ADDENDUM #6

Subj: Addendum #6 to **BPA-RFQ23-ISLAND (CONSTRUCTION OF A CONCRETE ISLAND AT MAYOR BILL CARPENTER PARKING GARAGE)**

Date: September 25, 2023

DRAWING NO.
PK-1

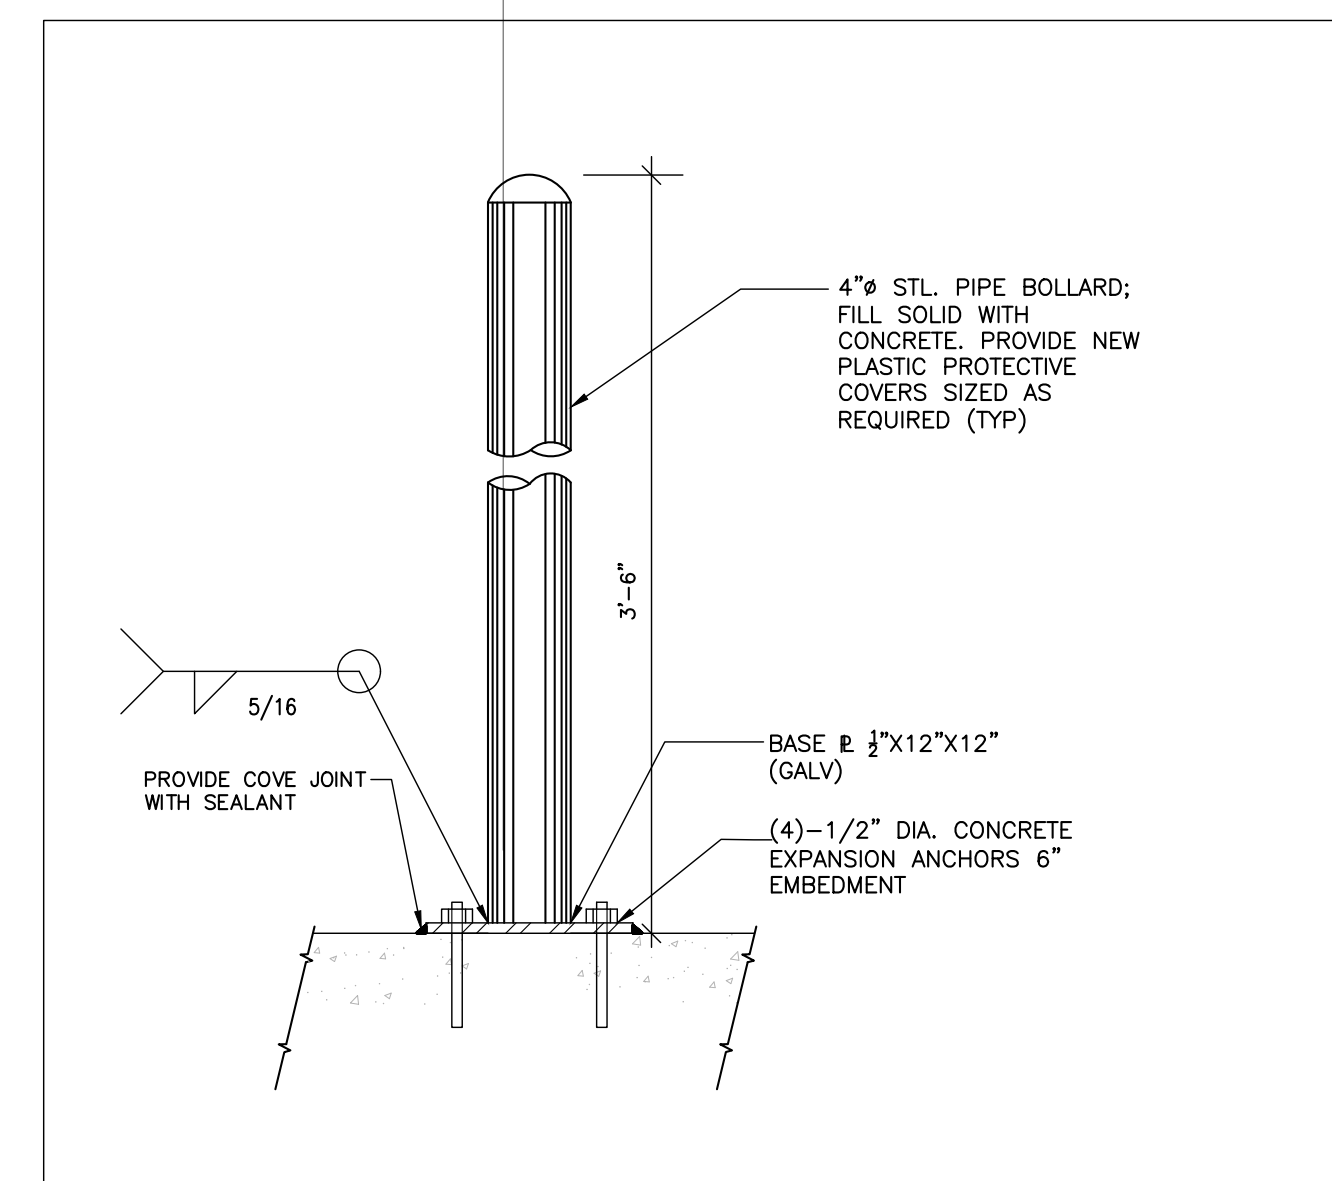
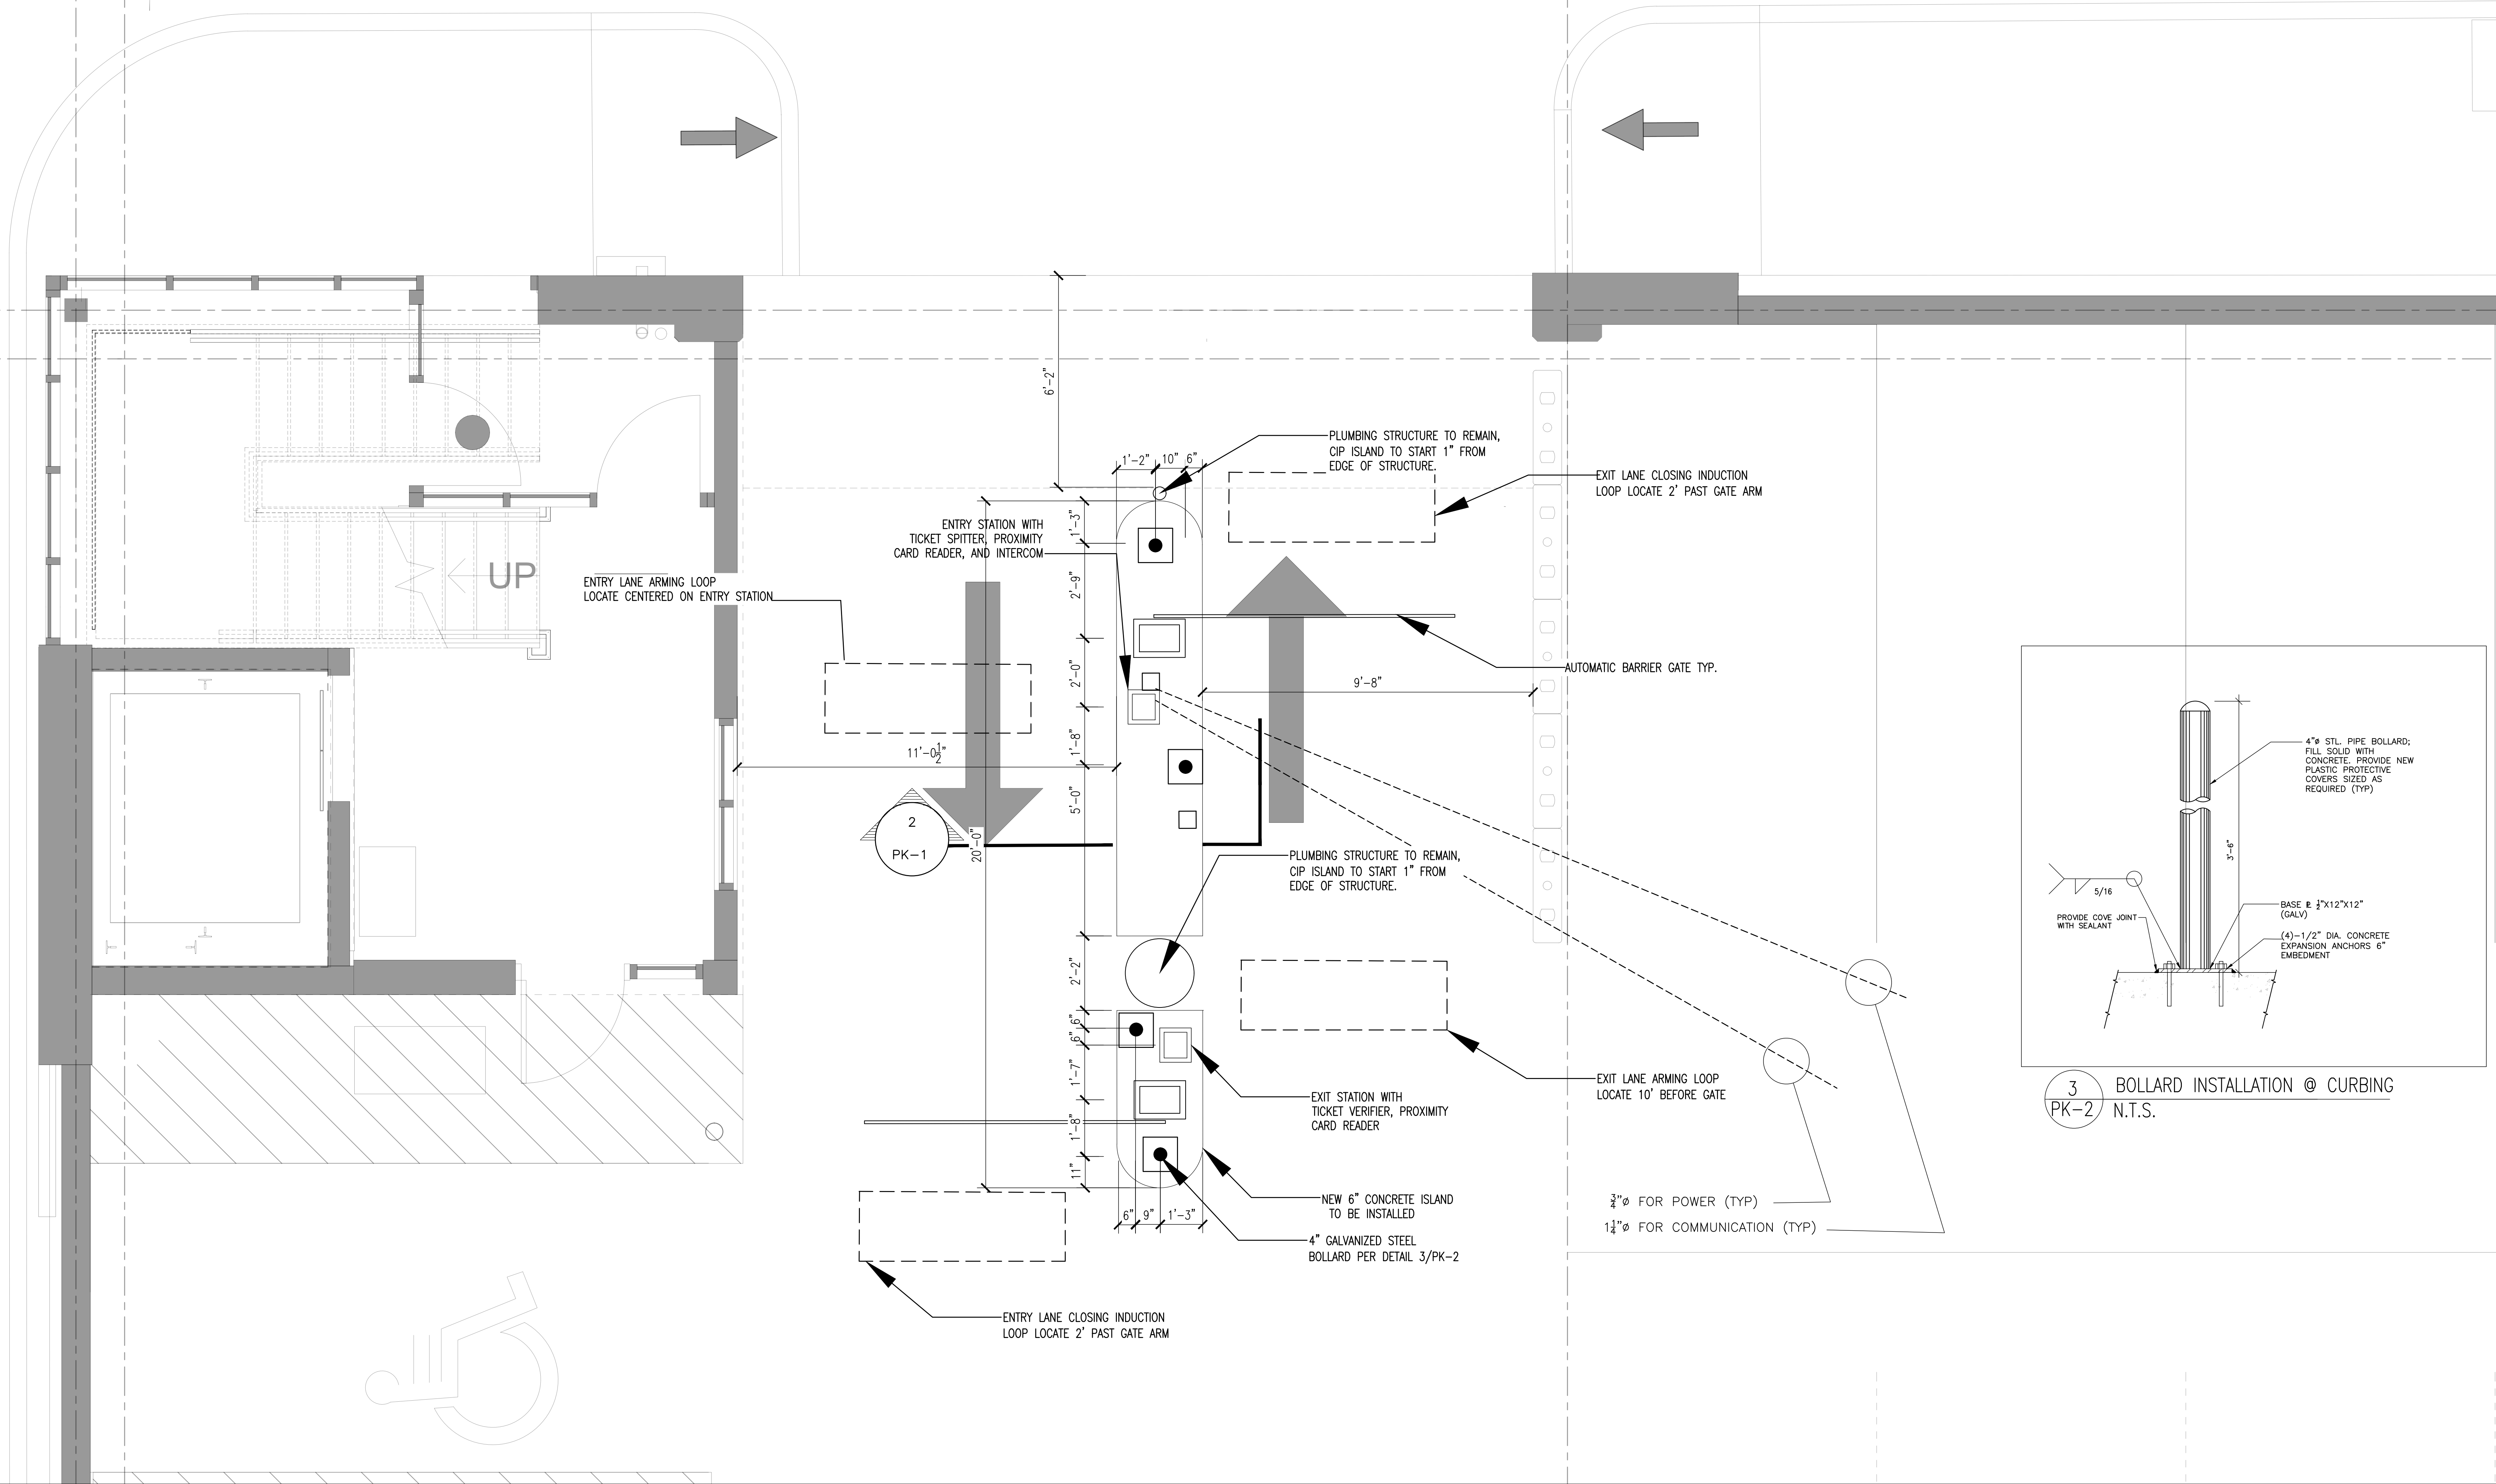
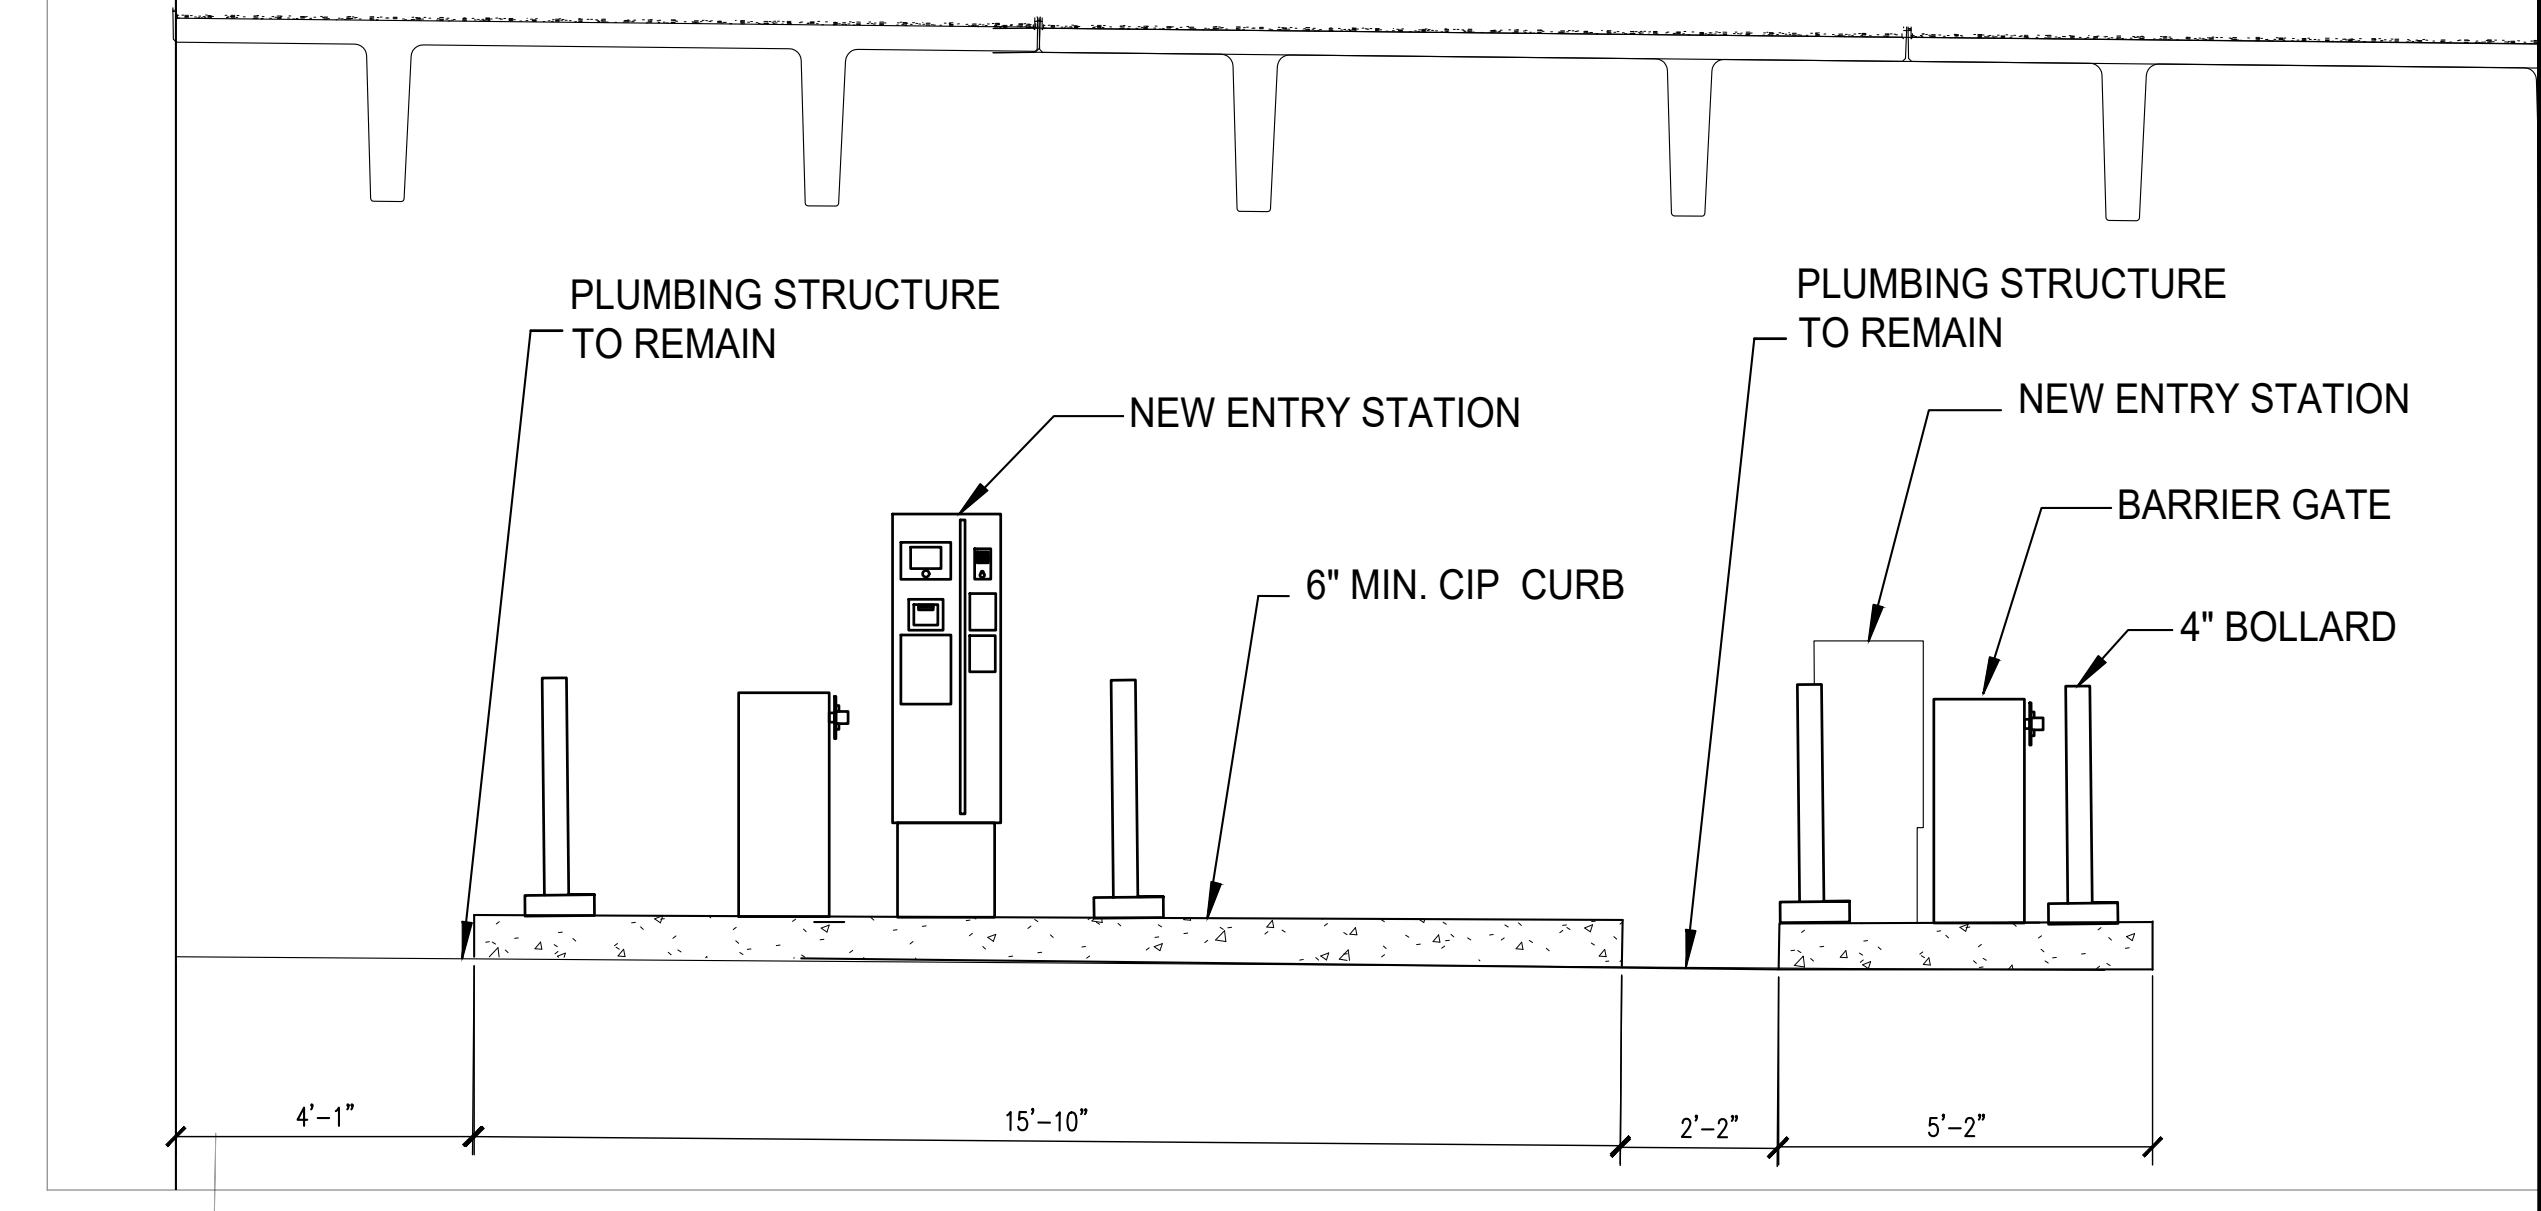
Please note the modified drawings attached which show proper orientation within and dimensions for the island reflective of the existing location of castings for the oil/water separator and drain cleanouts.

2. Are the casting [for the drain clean] and box [for the water/oil separator] to be raised or boxed out?

Answer: As shown on the attached amended drawings, the castings for both the drain clean-out and water/oil separator are to be essentially 'boxed out' where in the island will be poured around these obstructions and the island are located in the lane in such a manner that neither casting will be occluded by the island.

Answer: The castings will be "boxed out" as described above, not raised.
